NOTICE OF MEETING - PLANNING APPLICATIONS COMMITTEE 15 FEBRUARY 2022

AGENDA	ACTION	WARDS AFFECTED	PAGE NO
<u>KEY TO CODING</u>			
1. DECLARATIONS OF INTEREST	Decision		
2. QUESTIONS	Decision		
<u>PLANNING APPLICATION TO BE CONSIDERED</u>			
3. 200328/OUT - VASTEREN COURT, CAVERSHAM ROAD	Decision	ABBKEY	7 - 152

BY THE DIRECTOR OF ECONOMIC GROWTH AND NEIGHBOURHOOD SERVICES
READING BOROUGH COUNCIL
PLANNING APPLICATIONS COMMITTEE: 15th FEBRUARY 2022

Proposals: Outline planning permission with the details of access, appearance, landscaping, layout and scale reserved for later determination. A demolition phase and phased redevelopment (each phase being an independent act of development) comprising a flexible mix of the following uses: Residential (Class C3 and including PRS); Offices (Use Class B1(a); development in Use Classes A1, A2, A3 (retail), A4 (public house), A5 (take away), D1 and D2 (community and leisure); car parking; provision of new plant and renewable energy equipment; creation of servicing areas and provision of associated services, including waste, refuse, cycle storage, and lighting; and for the laying out of the buildings; routes and open spaces within the developme

Figure 9: Illustrative concept scheme model with highlighted route from North Station square to Christchurch Bridge through SSE site.

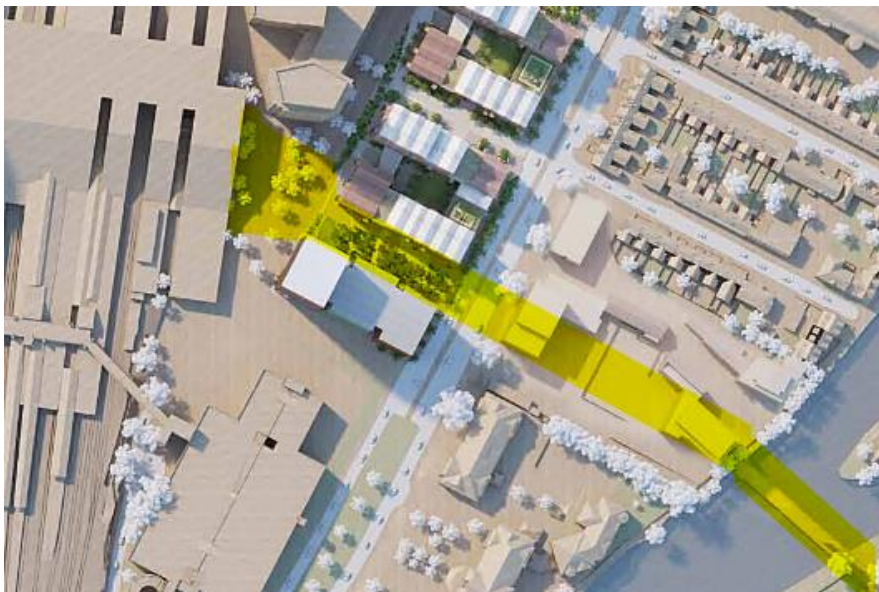
- 8.28 Whilst the Application offers a minimum 23m wide corridor through the site between Plots C and D and the alignment and dimension broadly accord with the RSAF, there remains a significant impediment in that the route requires coordination between the application site and the adjoining allocated SSE site.

Figure 10: Outline model of the proposed SSE Appeal Scheme amended with Aviva layout (as originally submitted) showing how the North-South Route is indirect with no direct line of sight from the Station to the River

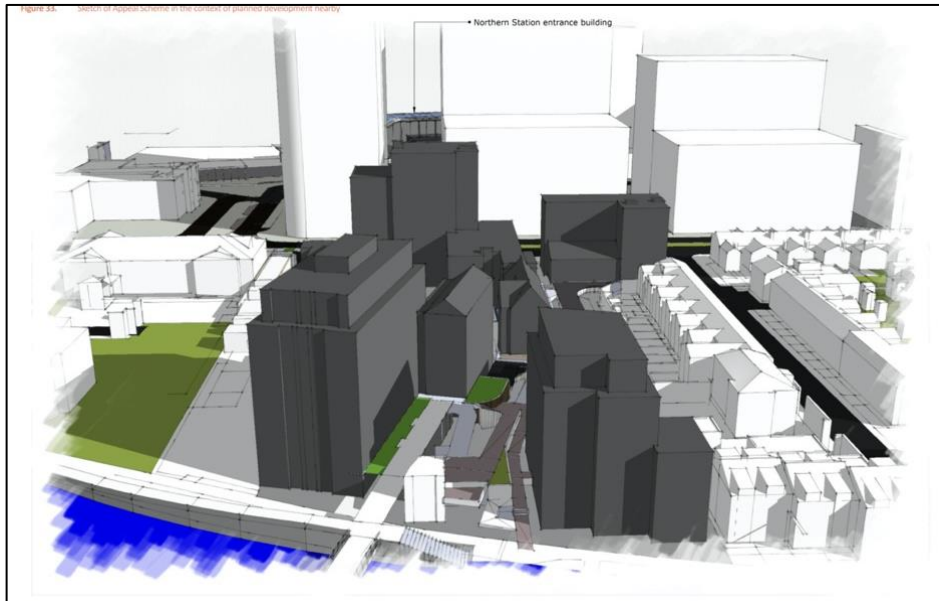
- 8.29 The LPA recognises that the Parameter Plans broadly follow the orientation shown on diagrams in the RSAF and local plan. However, it does not, and possibly cannot take account of the future development of the CR1g site. This would, in turn, lead to a heavily compromised north-south route through the area, which would fundamentally conflict with one of the overarching movement priorities.
- 8.30 Therefore, the development as proposed may prevent the achievement of the high-quality north-south pedestrian and cycle link: This is an essential requirement of policy for this area, through a failure to provide a satisfactory alignment for the connection through the site such as that this compromises the route.

Fig 13 - Tall building location guidance.

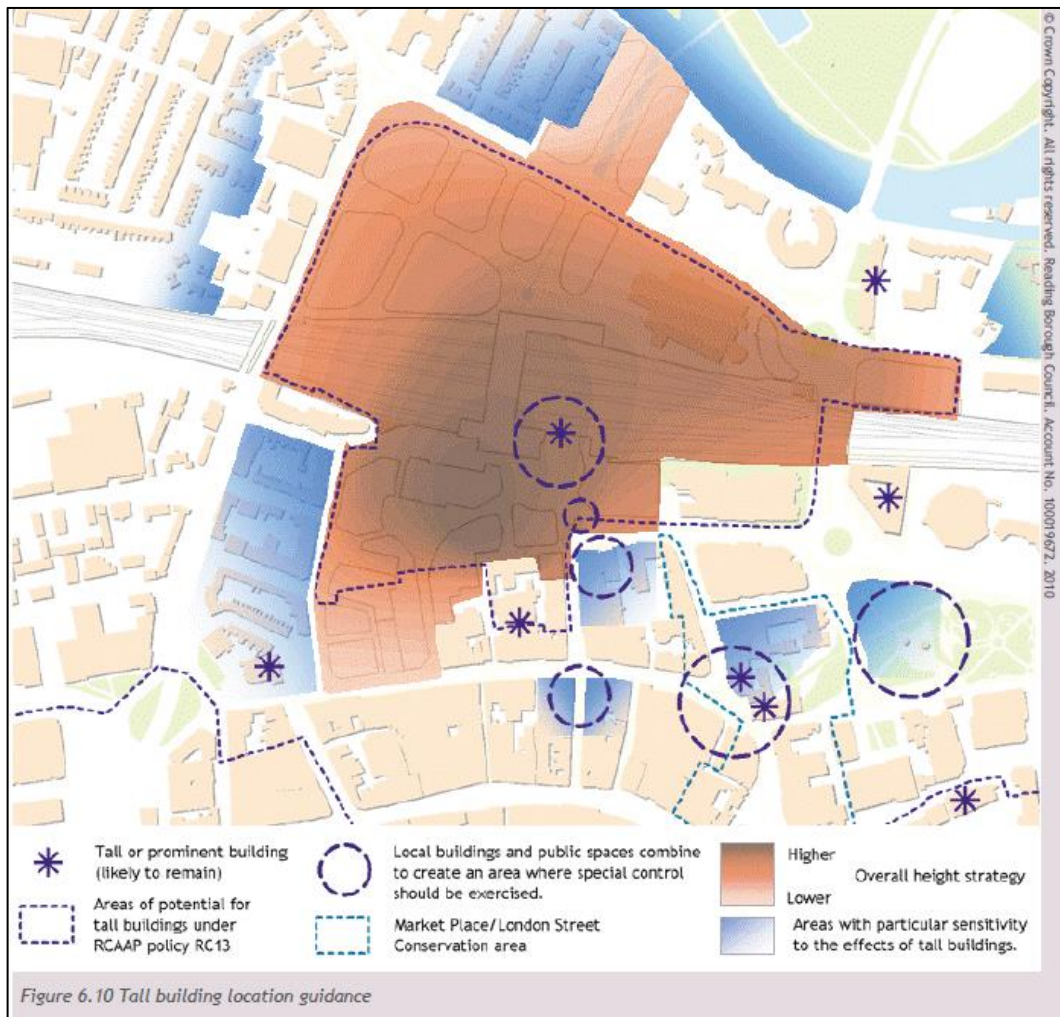
- 8.36 Policy CR10 is clear that the tallest buildings should be close to the station and step down in height from that point toward the lower buildings at the fringes. The policy also requires the creation of a “coherent, attractive and sustainable cluster of buildings with a high-quality public realm”. This cluster extends south beyond the CR11E site allocation to include Station Hill south of the railway. Another key policy requirement of CR10a is that proposals are to “Ensure that adequate space is provided between the buildings to avoid the creation of an overly dense townscape and to allow buildings to be viewed as individual forms”.
